INDESIT company

Model type:
MTB4511NFGR

Commercial code:
F029349

RE0200T0 Exploded views

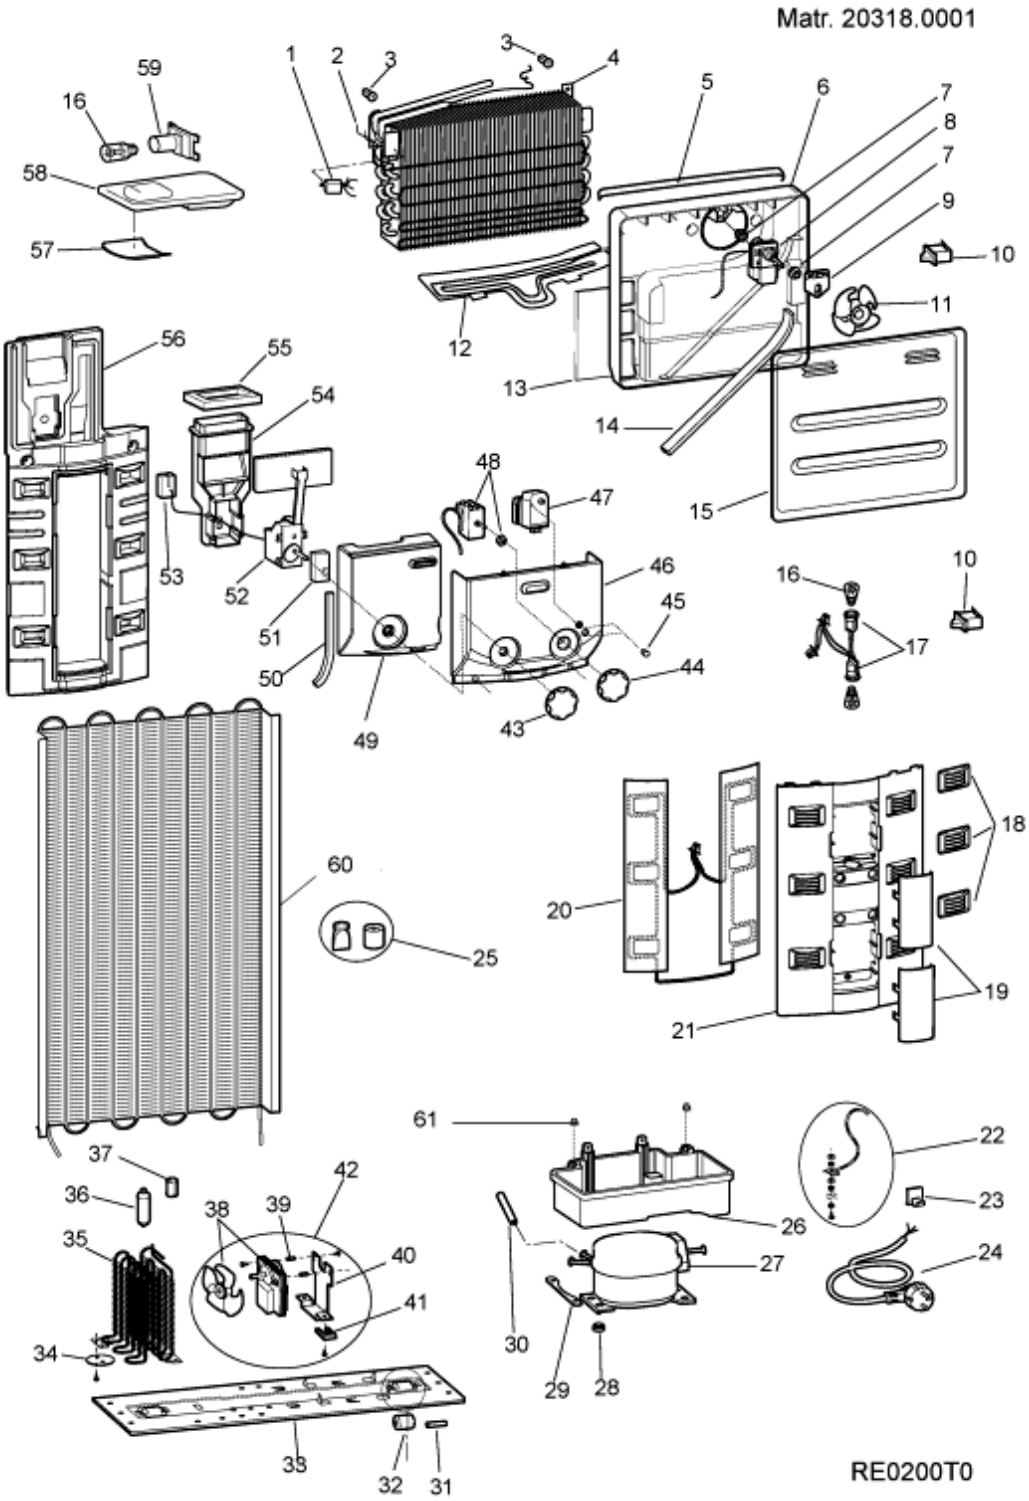
0999355: STATIC CONDENSER USAGE

Since 12/03/04 static type condenser will be used on export no-frost models. Due to this reason condenser fan motor has been eliminateded. New static condenser will be managed with 095426 spare part code. Old parts can be supplied from warehouse for previous appliances.

0999360: modification on freezer fan motor

Since 01 July 2004 freezer fan motor has been modified to reduce noise level on no frost models that are produced in Manisa plant. (Old fan motor has grey cover, new fan motor has light green cover.) Spare part code remains the same. If you replace the old fan motor with the new fan motor, rubber for fan has to be replaced with the new one and sponge should not be used with the new fan motor.

0999361: USAGE OF SHORT FIN EVAPORATOR ON 450LT NO FROST MODELS

Since January 2005 short fin evaporator will be used on 450lt no frost models.

old evaporator 174511
new evaporator 111112

re0198t0 Exploded views

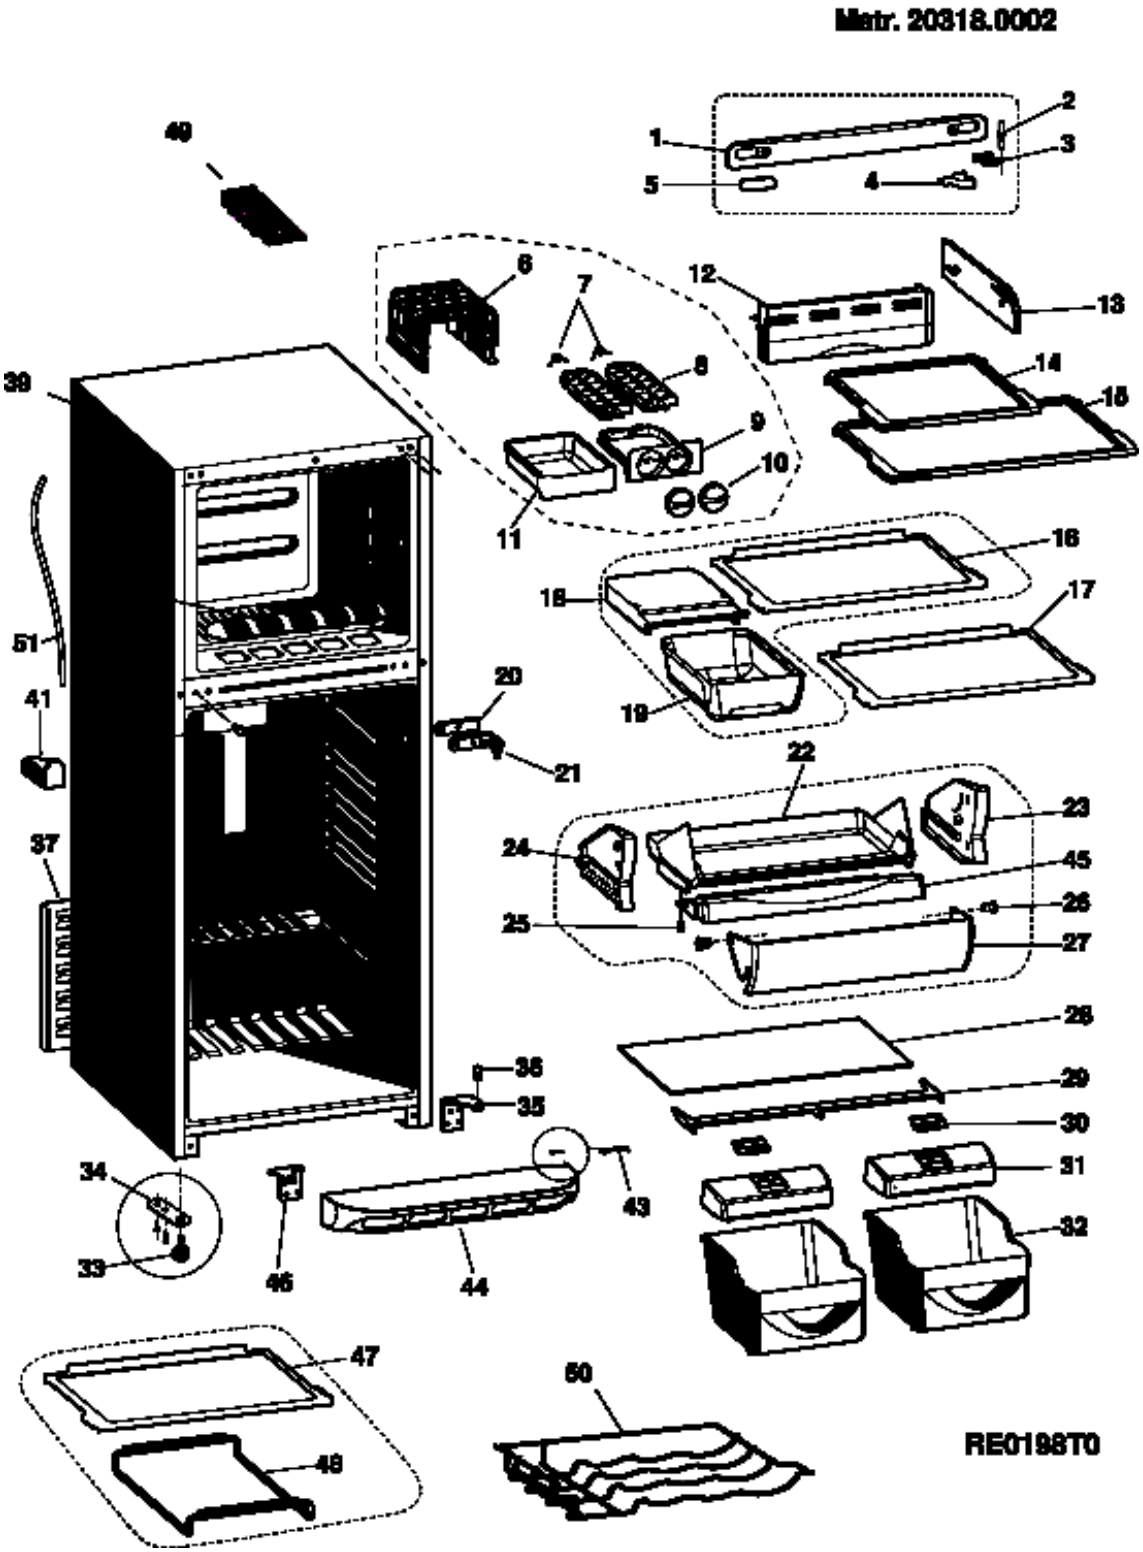
0999357: plastic compressor basement

Plastic compressor basement will be used on refrigerators since this reason adjutable foot and except single door bottom hinge have been changed. New hinge will be managed with a new code. The new bottom hinge can be used on both left and right sides.

New adjustable foot;
89682- white
89686- black

New bottom hinge assembley with adjustable foot;
110081- white
110522 - black
